STAFF RECOMMENDATION

129 South 11th Street

February 19, 2014

Application: New construction - addition

Figure 2. The addition requires the removal of chimneys, rear dormer and porch

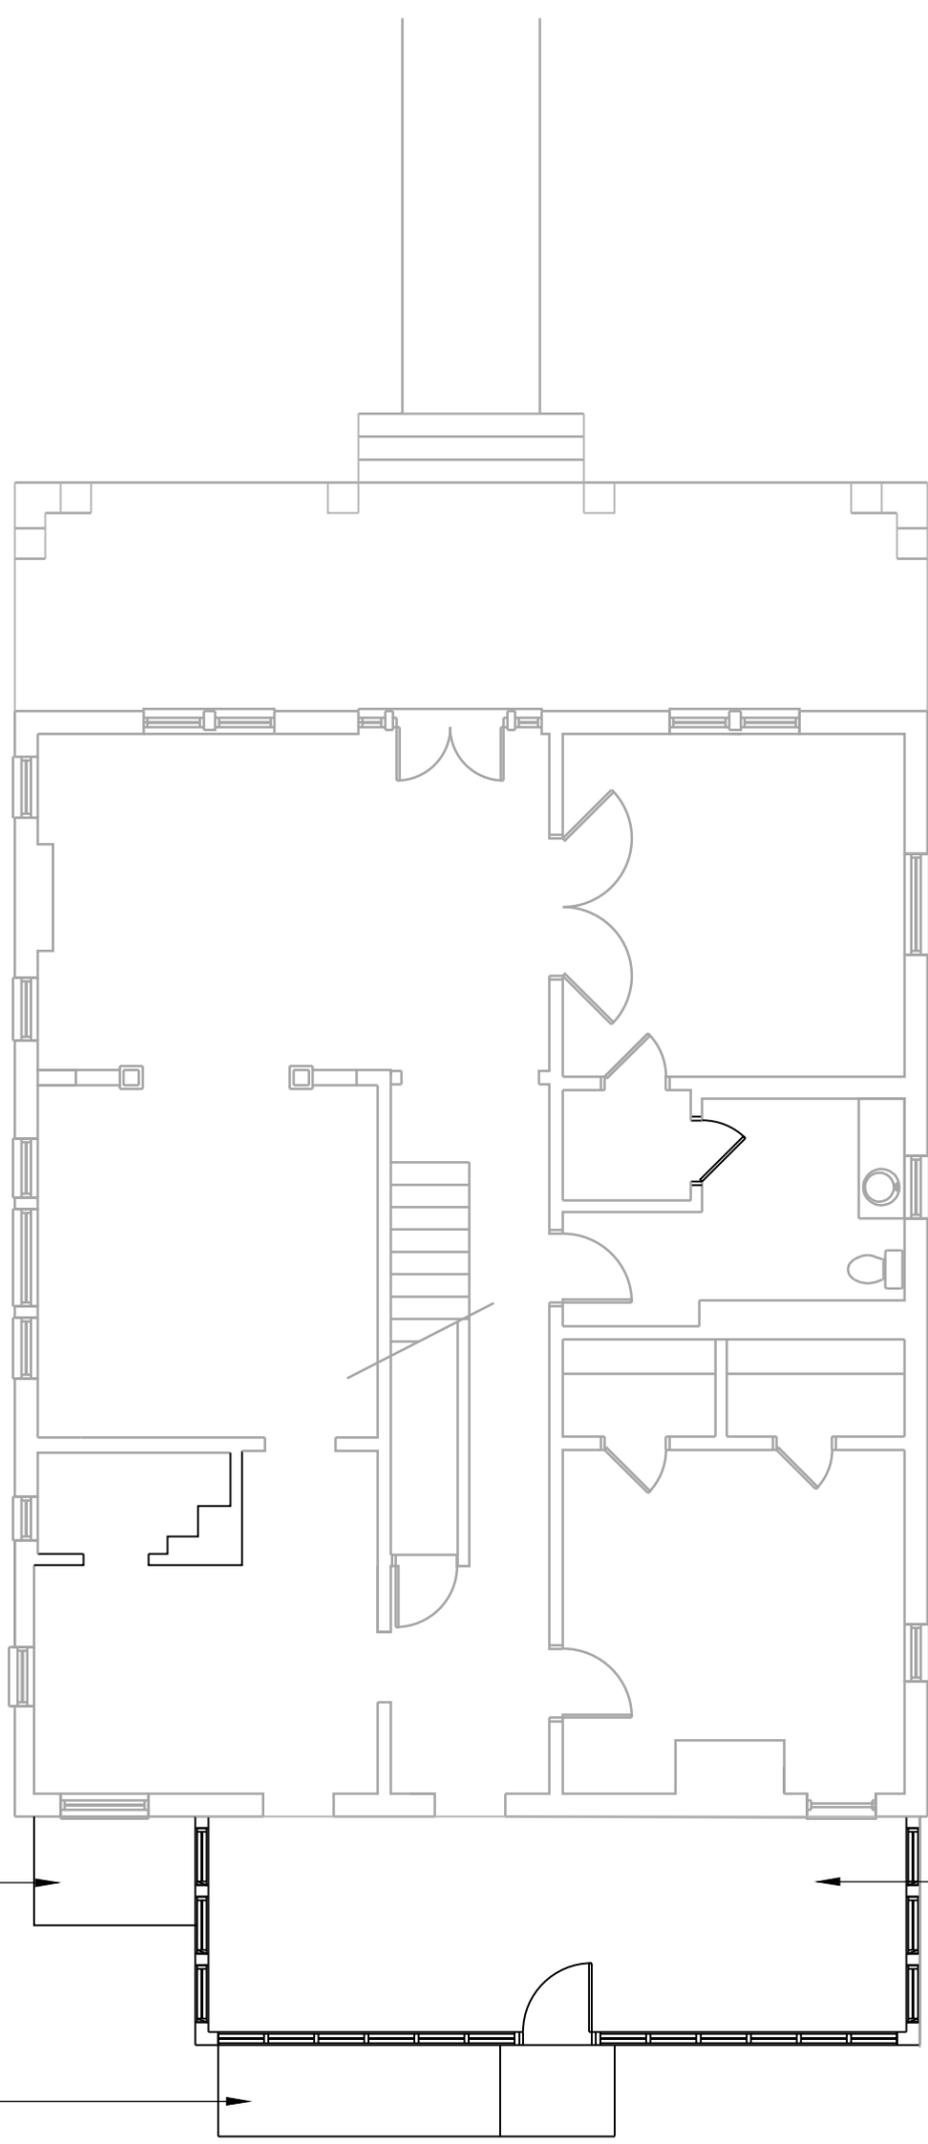
Demolition: The proposed addition requires the demolition of an existing rear porch, dormer and chimneys. Although these elements are likely original to the house, they are not visible from the street and are not considered to be character-defining features of the house. This partial demolition meets Section IV.B.2 for appropriate demolition and does not meet Section IV.B.1 for inappropriate demolition.

DEMOLITION PLAN - MAIN LEVEL

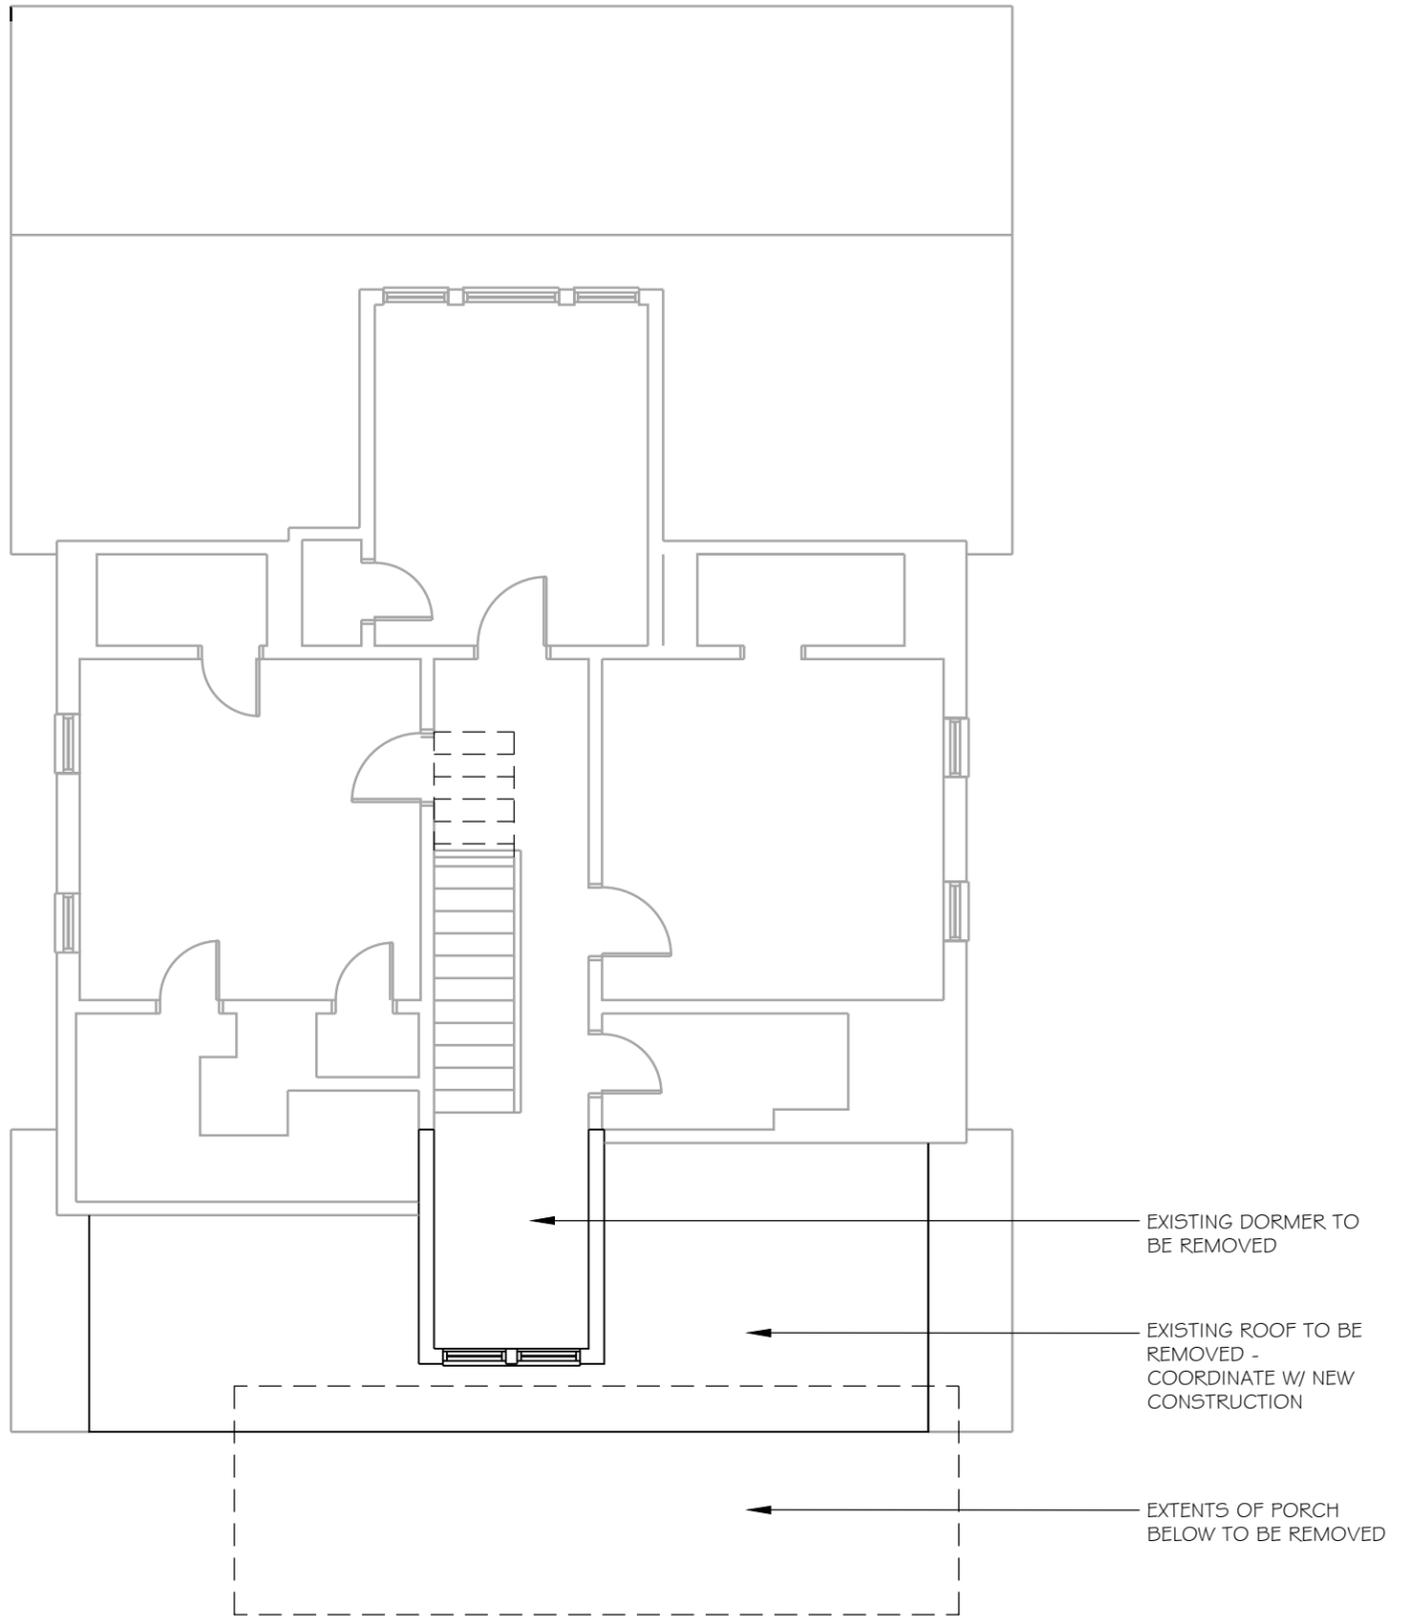
EXISTING CONCRETE
PAD TO BE REMOVED

EXISTING ENCLOSED
PORCH STRUCTURE TO
BE REMOVED

EXISTING CONCRETE
RAMP TO BE REMOVED

SOUTH ELEVATION

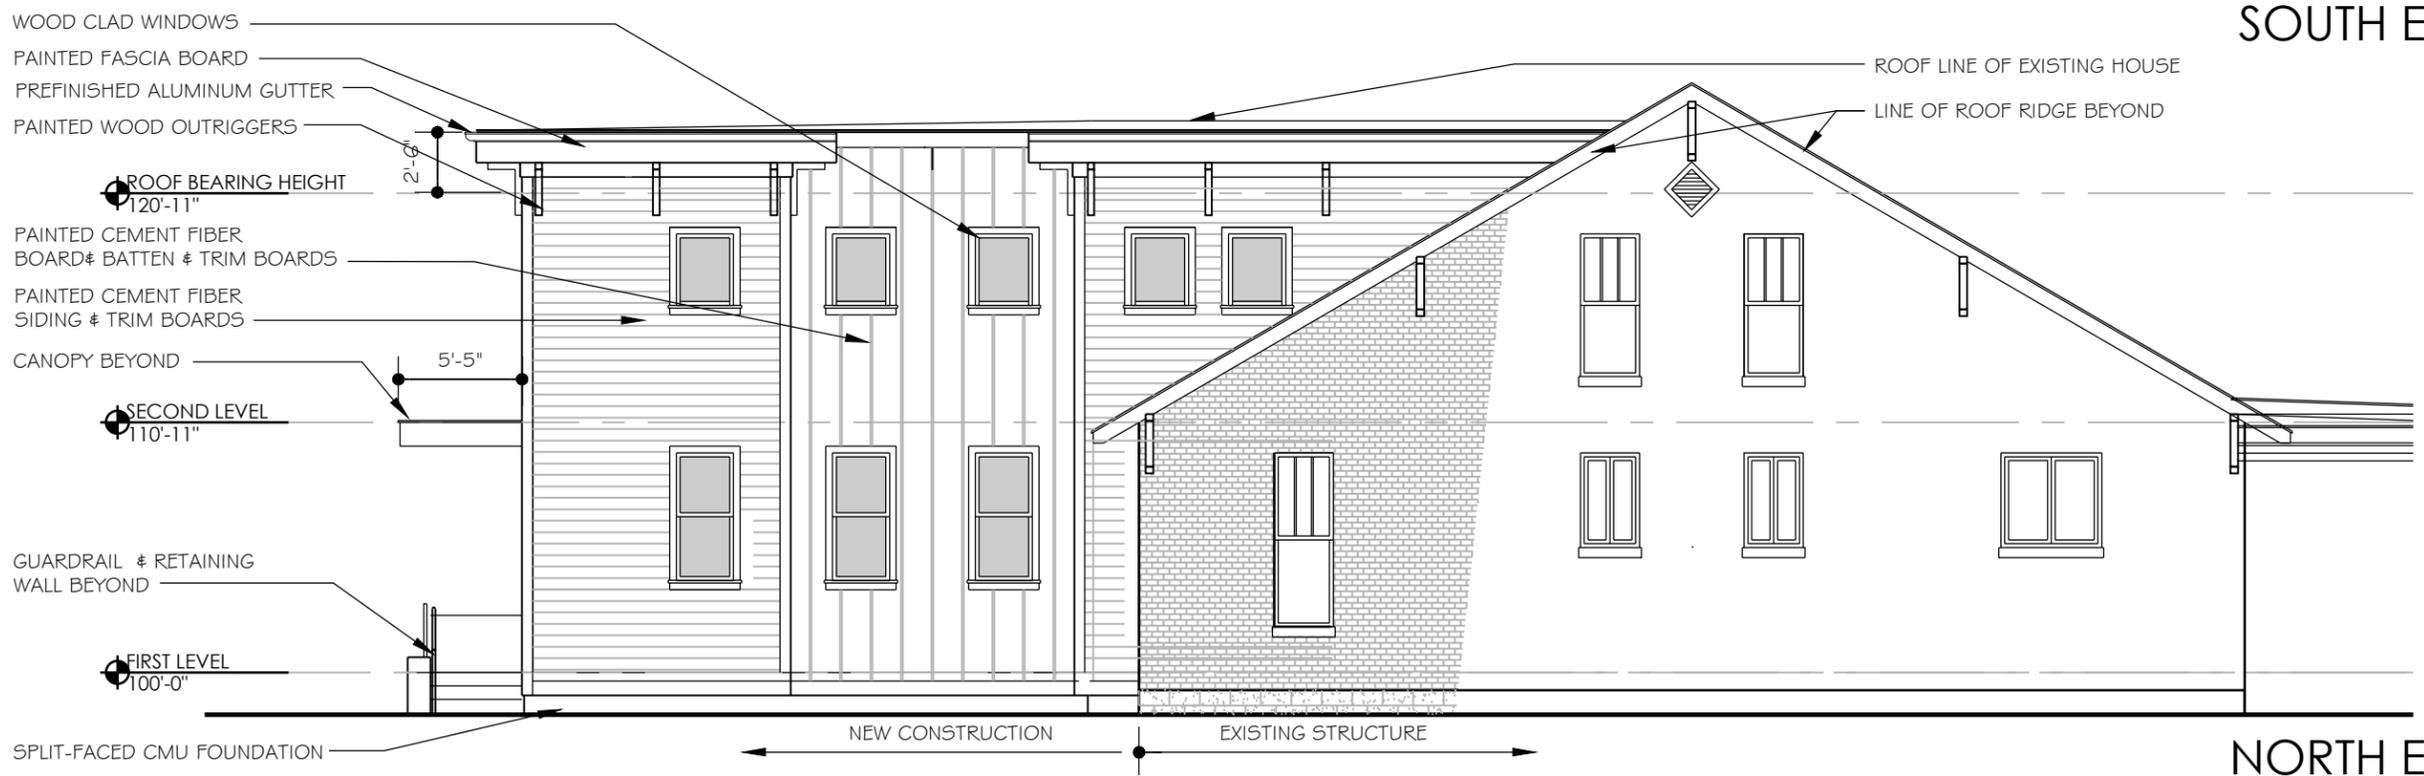
Proportion and Rhythm of Openings: Most of the windows on the proposed addition are twice as tall as they are wide, thereby meeting the historic proportions of openings. Second-story windows on the side facades are a more square shape. Only two windows are proposed on the south façade, and there are two horizontal windows on the rear façade. Since these are all toward the rear of the addition, they will be minimally visible, and Staff finds the project's proportion and rhythm of openings to meet Section II.B.7.

SITE PLAN

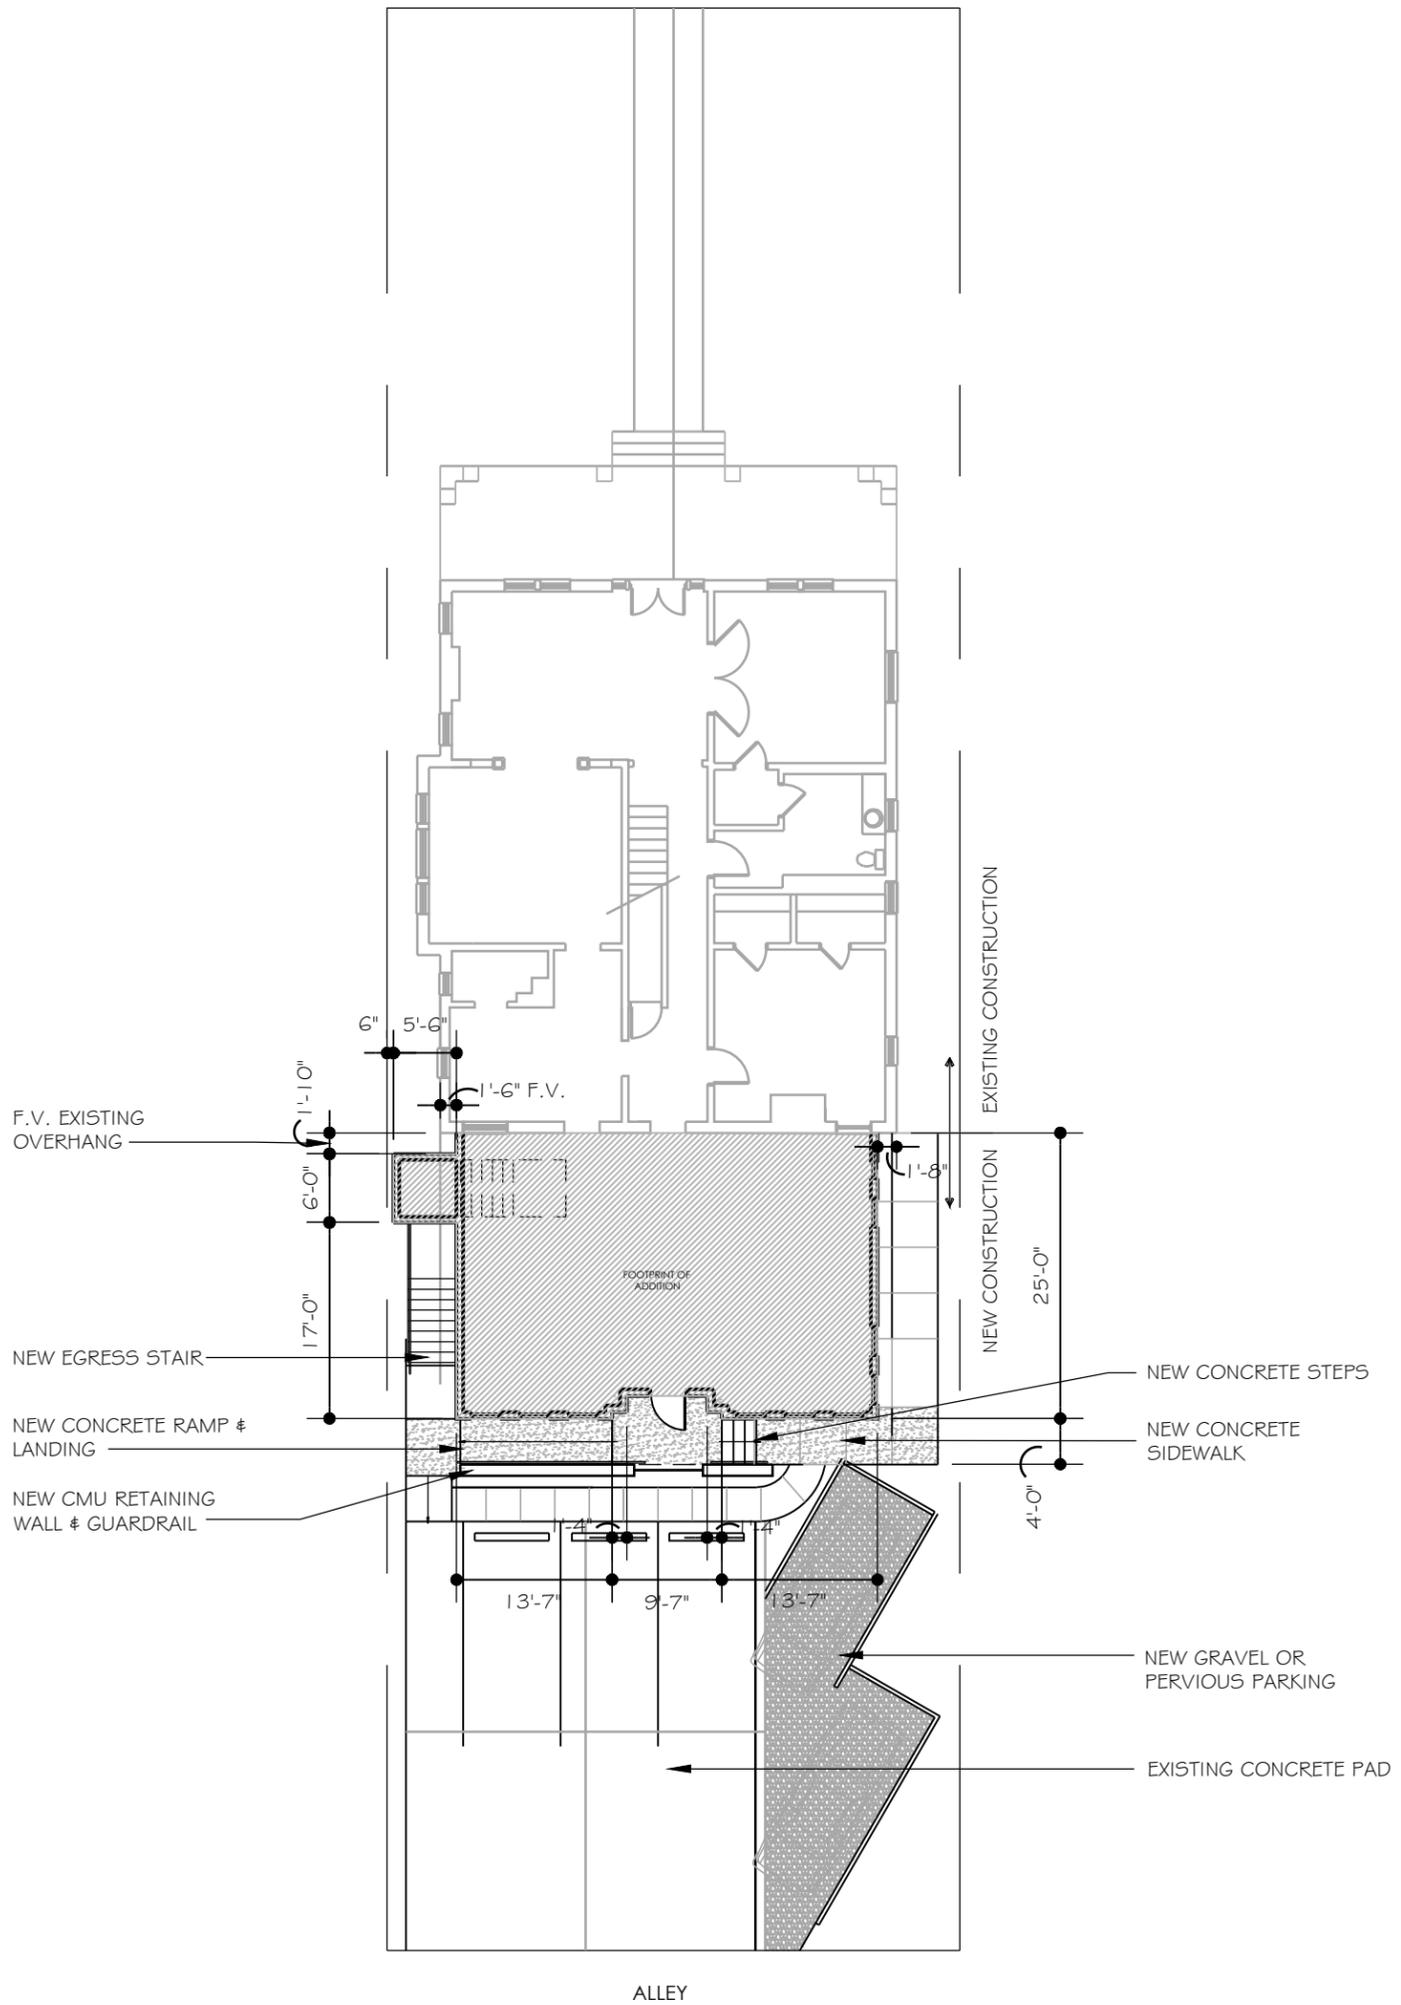
Setback and Rhythm of Spacing: The addition will be six feet (6') from the sides and forty-two feet (42') from the rear property line, more than meeting the zoning requirements of five feet (5') on the sides and twenty feet (20') minimum rear setback. The project meets Section II.B.3.

Location & Removability: The location of the addition at the rear of the house is appropriate. It is not taller or wider than the house. The corners of the house will remain intact and visible. The insets at the back corners are one foot eight inches (1'8"), less than the Commission's preferred two feet (2'), due to an existing window and door opening close to each corner. The applicant desires to maintain those openings within the addition, and the proposed inset differs only by four inches (4") from the normal requirement. In addition, there is a change in material which provides an additional four inches (4") in setback. Staff recommends making the exception in this case.
